JAEA-Technology 2012-001

超深地層研究所計画

主立坑断層を対象としたボーリング調査結果報告書

List of errata

p.89  
図 3.4.2-6

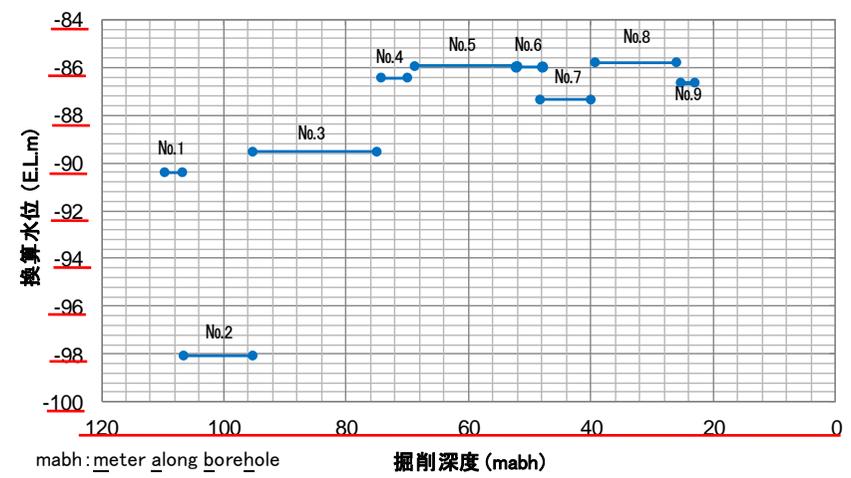
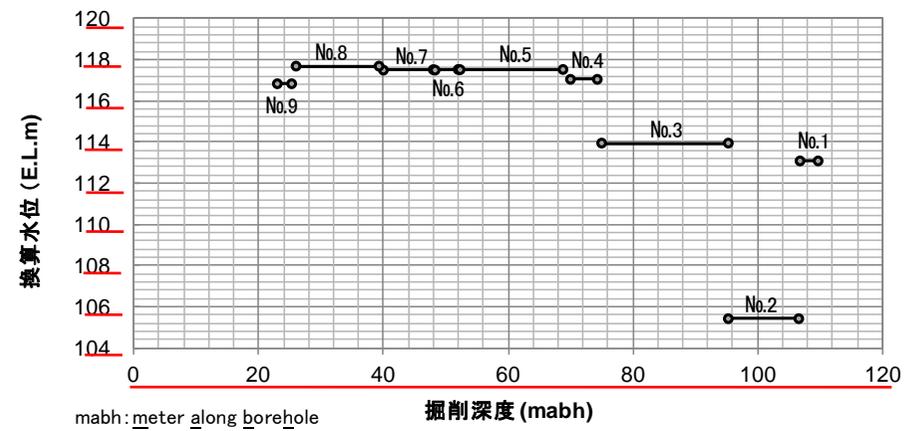
正誤表

mabh: meter along borehole  
 掘削深度 (mabh)

Correct

mabh: meter along borehole  
 掘削深度 (mabh)
